# St. Peters Anglican College, Community Hub, Sports & Recreation Centre Project

Southern Regional Planning Panel  
Request for Information

Report prepared by Colliers International Project Leaders  
14 December 2023

**Application No.** DA0078/23

**Figure 2.1 – Vehicle access paths**

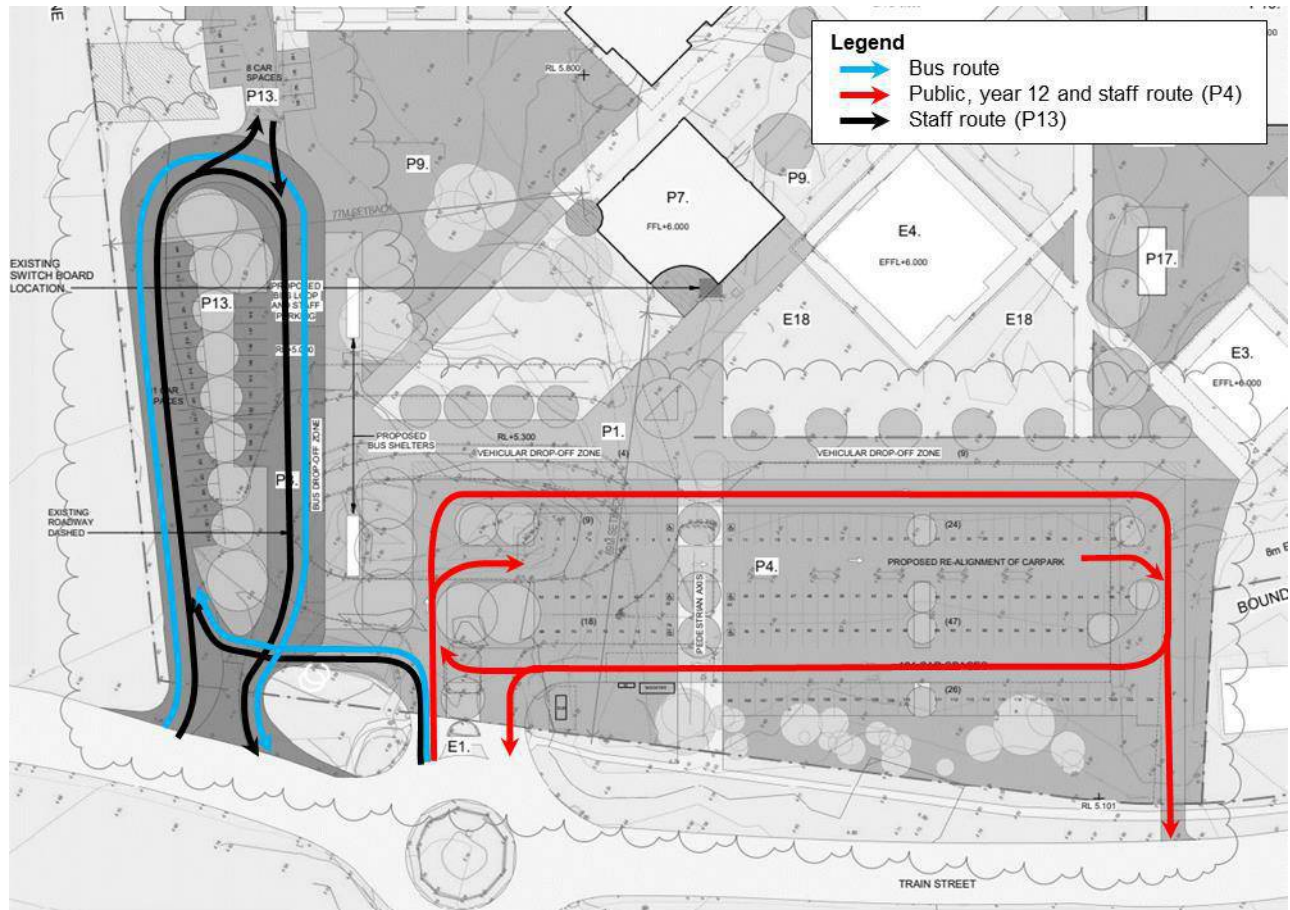
*3. Consideration of the safety and manoeuvrability aspects for vehicles entering the staff car park (P4) from the east, using the roundabout, and clarification of traffic control arrangements for this intersection.*

As shown, it is proposed to retain the existing vehicle access point in its current form with primary access via Train Street for the eastern on-site car park (P4), as well as the public drop off and pick up zone. An additional egress from P4 (left turn out) at the eastern edge of the car park has been provided to reduce the quantum of vehicles using the Train Street roundabout. The proposed location will result in no loss of on-street parking.

P4 operates with one-way clockwise circulation. All vehicles must enter via the Train Street roundabout. Vehicles can then either travel to the northern aisle that contains an expansive pick up / drop off parking area along the northern kerb, or else enter the centre aisle that contains standard parking spaces. All vehicles must travel east, and can either egress directly to Train Street via the new egress if they are traveling east, or travel west along the southern parking aisle back to the roundabout to egress site. In the unlikely event that a vehicle needs to re-circulate through P4, a cut-through is provided from the southern aisle. This avoids the need for vehicles to re-circulate back into the site via the Train Street roundabout. This is also consistent with the existing site layout that allows vehicles to circulate in a one-way clockwise direction through the parking area, and re-circulate back to the parking area internal to the site without the need to egress back onto Train Street.
